**SUBJECT: HOPE CREEK GENERATING STATION – STAFF ASSESSMENT OF
RESPONSE TO 10 CFR 50.54(f) INFORMATION REQUEST – FLOOD-
CAUSING MECHANISM REEVALUATION (CAC NO. MF3789)**

STAFF ASSESSMENT BY THE OFFICE OF NUCLEAR REACTOR REGULATION
RELATED TO FLOODING HAZARD REEVALUATION REPORT
NEAR-TERM TASK FORCE RECOMMENDATION 2.1
HOPE CREEK GENERATING STATION
DOCKET NO 50-354

Figure 3.2-3. Precipitation Hyetograph Used in the Local Intense Precipitation Analysis (FHRR Figure 2.1-2 (PSEG, 2014a))

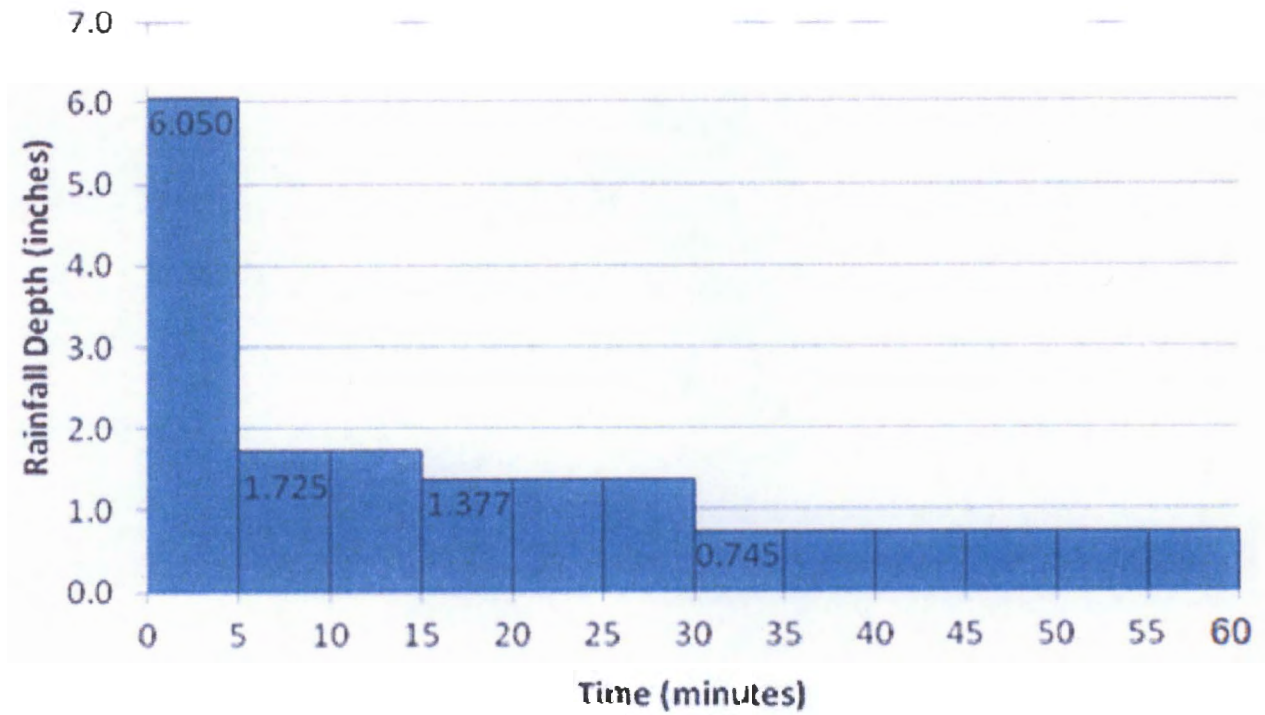
The licensee stated that the PMP precipitation hyetograph, shown in Figure 3.2-3 was developed using the methodology described in NUREG/CR-7046 (NRC 2011e). The licensee used 5-min increments to construct the hyetograph, with the most intense precipitation flux applied during the initial 5-min increment with the precipitation rate decreasing during successive time increments (PSEG, 2014a). The NRC staff verified that the licensee followed the example described in Appendix B of NUREG/CR-7046.
